UNITED STATES PATENT AND TRADEMARK OFFICE

APPLICATION NO.	FILING DATE	FIRST NAMED INVENTOR	ATTORNEY DOCKET NO.	CONFIRMATION NO.
09/802,858	03/12/2001	Masaharu Onda	040679/1224	7809

Office Action Summary

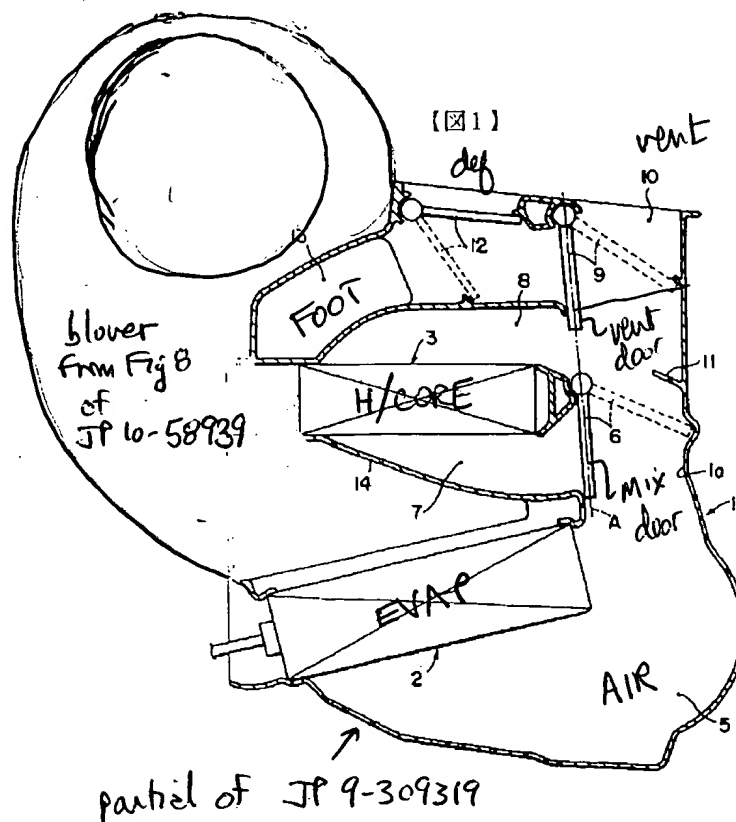
Onda in Figures 1 and 5 shows the claimed subject matter with the exception of a down-flow blower.

JP 10-58939 teaches a downflow blower in Figure 8. To have used the down-flow blower of JP'939 in Onda to advantageously avoid a side mounted blower to "miniaturize" (see Abstract of JP '939) the resulting structure would have been obvious to one of ordinary skill in the art.

The modification is illustrated below:

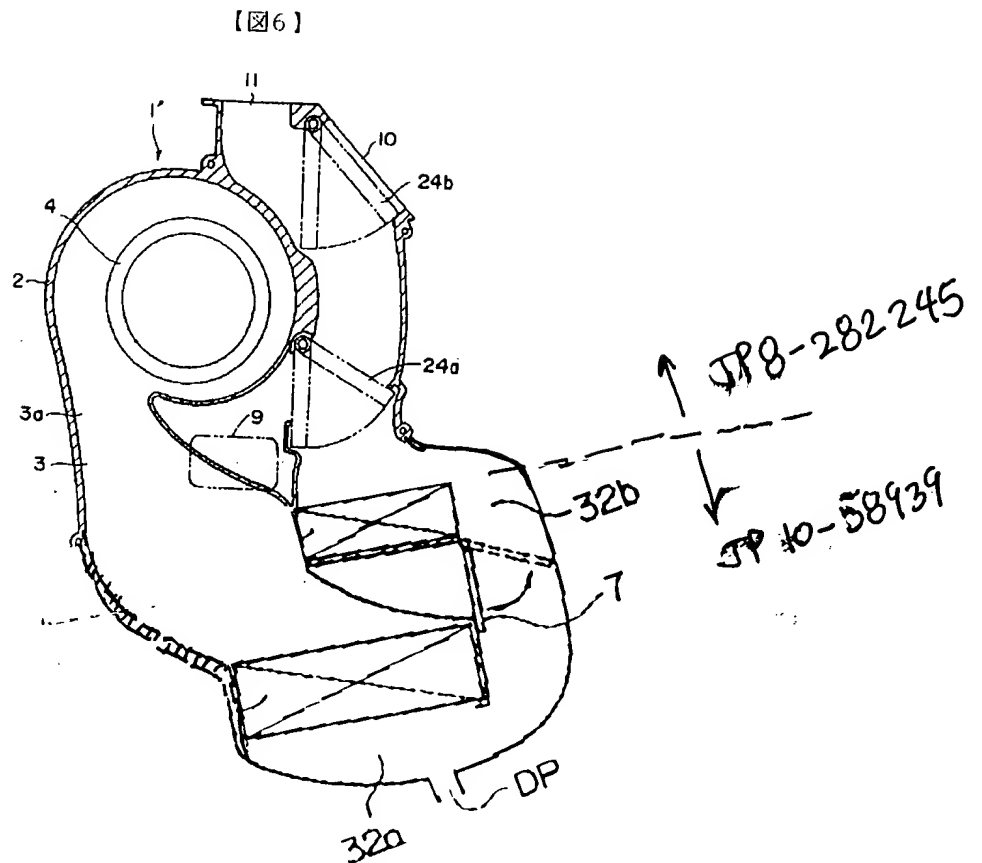
Figures 8-12 of JP '939 bear a striking resemblance to what is disclosed in this application, with the exception that the foot outlet is formed on the front part of the casing rather than closer to the blower.

JP'245 teaches forming the foot discharge 9 at the position claimed by applicants.

To have combined the respective teachings of JP '939 and JP'245 to obtain the structure shown on the next page would have been obvious to one of ordinary skill in the art to obtain a more compact structure.
